No. 95-10

MerCruiser MCM D7.3L/270 Diesel Stern Drive Replacement

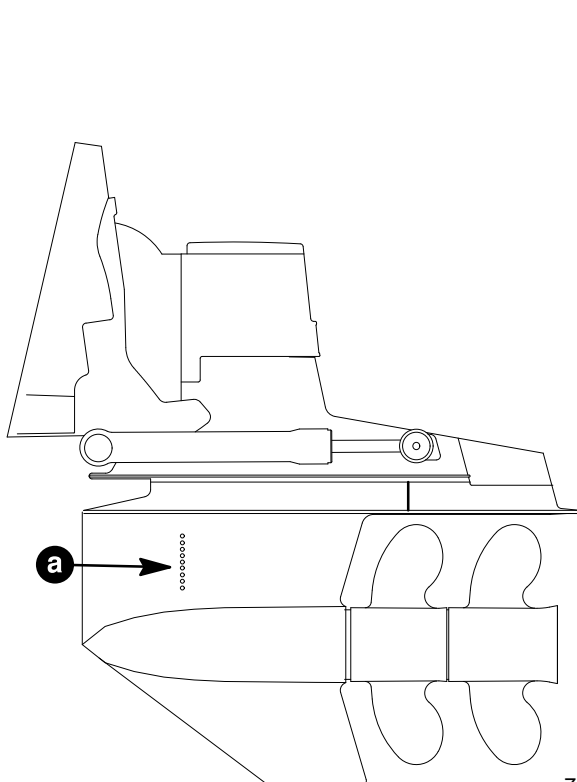
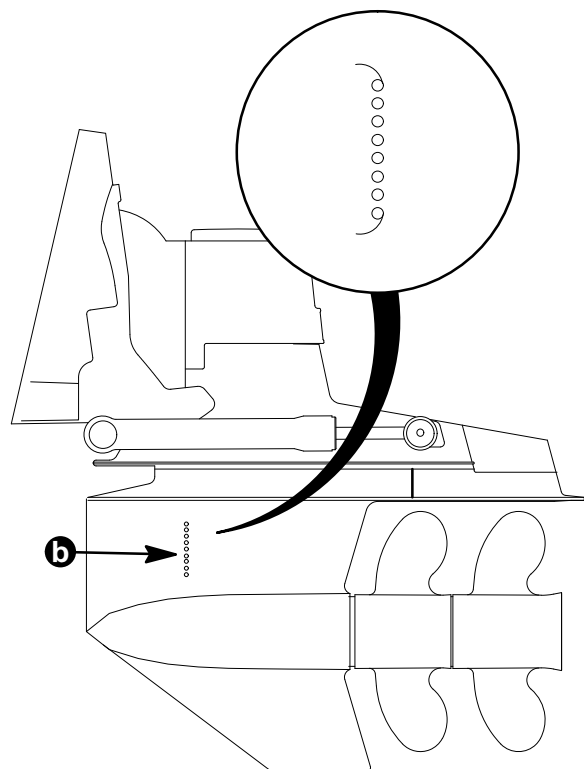
An overheat situation could develop if the D7.3L/270 diesel model engines are mated with a 1996 Bravo Three.

If replacing a 1994 or 1995 Bravo Three with a 1996 Bravo Three (all gear ratios) a thru hull water pick up kit (P/N 88845A2) is required to supply adequate water flow to the engine. The 1996 Bravo Three has an 8 hole water pick up, whereas the 1994 and 1995 Bravo Three had a 9 hole water pick up.

a - Water Intake - 9 holes 94-95 M.Y.

b - Water Intake - 8 holes 1996 M.Y.
